## Product Support Bulletin

### **XDRIVE POWER RELAY RETROFIT KIT 000-078-972**

# xDrive Power Relay Retrofit

**Kit No. 000-078-972**

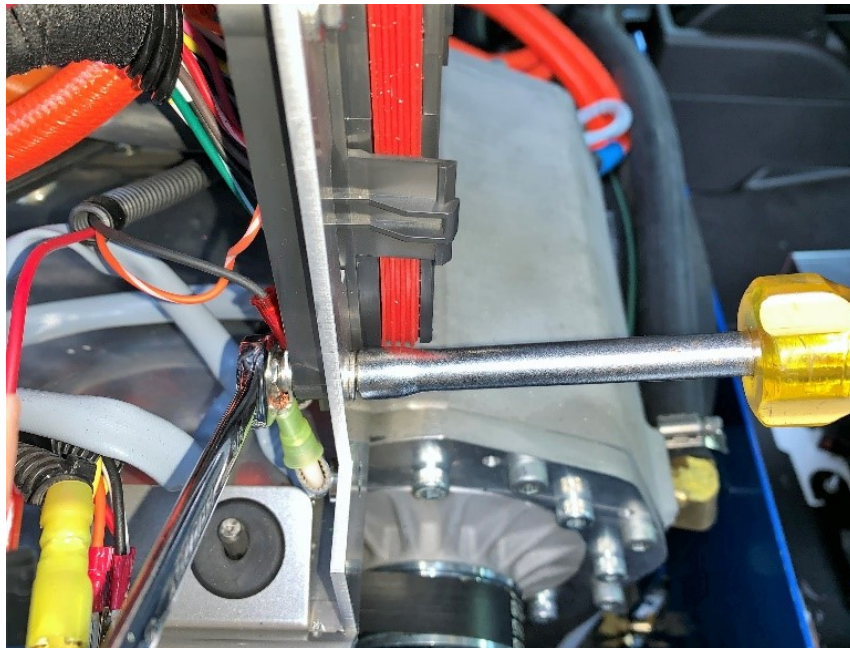
- 6) Depress the locking tab on the top four relay terminals and gently pull the wire out from the back of the fuse panel.

- 7) The four wires should come out like this.

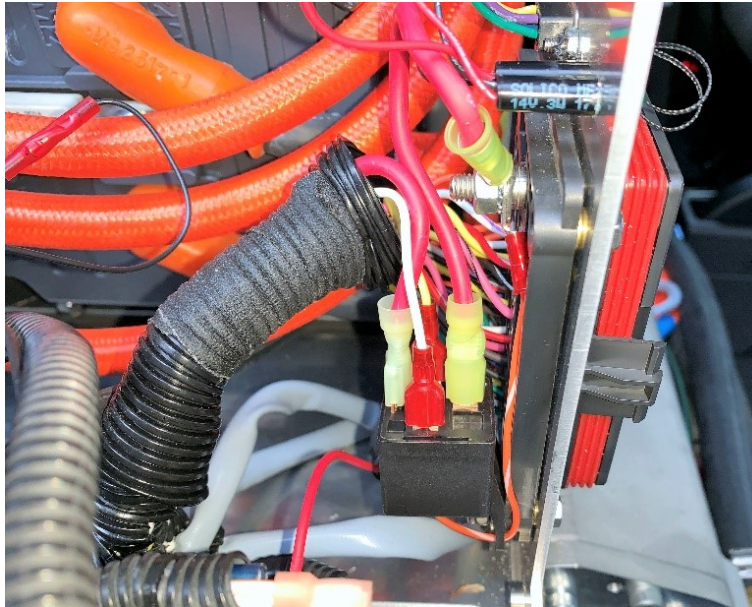
12) Mount the relay provided in the kit to the exposed bottom left mounting screw stud.

- 13) Attach the wires to the relay. The two 10-gauge red wires go on pins 30 and 87. The yellow and white wires attach to pins 85 and 86.
